# UNITED STATES PATENT AND TRADEMARK OFFICE

10/750,633

TURNER, SAMUEL A

DATE MAILED: 01/25/2006

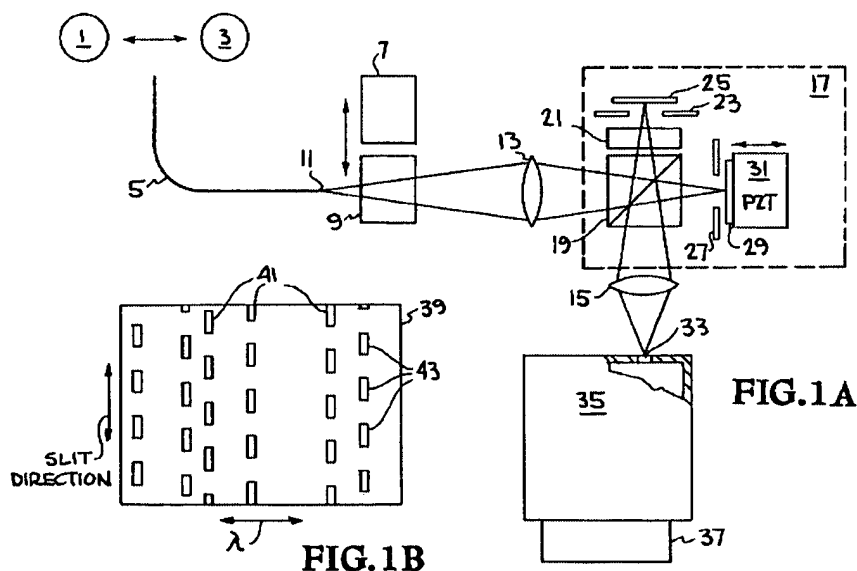
Claims 1-9 are rejected under 35 U.S.C. 102(b) as being clearly anticipated by Erskine(6,351,307).

With regard to claim 1, Erskine teaches a dispersing Fourier Transform interferometer, comprising:

a Fourier Transform Spectrometer having an input for receiving a source light and an output(17); and

a dispersive element having an input coupled to the Fourier Transform Spectrometer output and an output for providing the resulting multiple narrowband interferogram outputs of different wavelengths representative of the source light input(35).

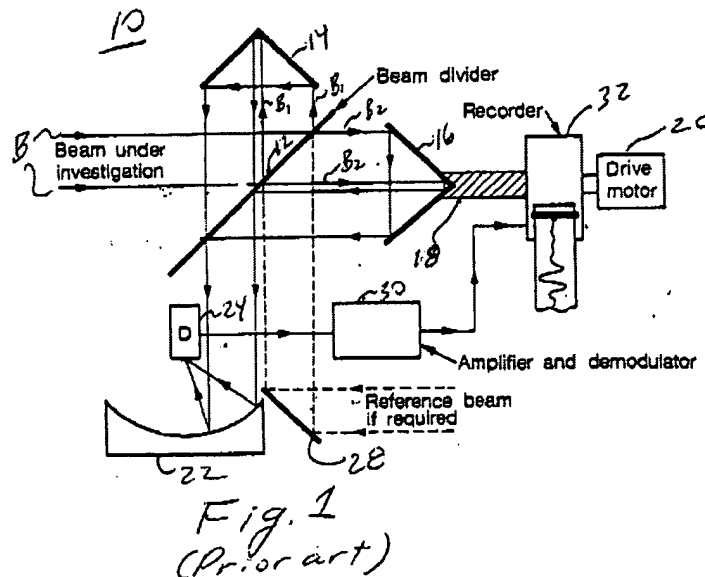
Claims 10-28, and 33-35 are rejected under 35 U.S.C. 103(a) as being unpatentable over Erskine(6,351,307) in view of applicant's prior art figure 1.

It would have been obvious to one of ordinary skill in the art at the time the invention was made to modify the Erskine apparatus by replacing the Michelson interferometer 17 with the Michelson interferometer 10 of applicant's prior art figure 1. While both are Michelson interferometers, applicant's figure 1 prior art includes a separate monochromatic reference beam which interferometrically

measures the displacement of the scanning mirror 16. This would have been superior to the Michelson interferometer of Erskine which determines the optical path difference by the current which drive the PZT actuator 31.
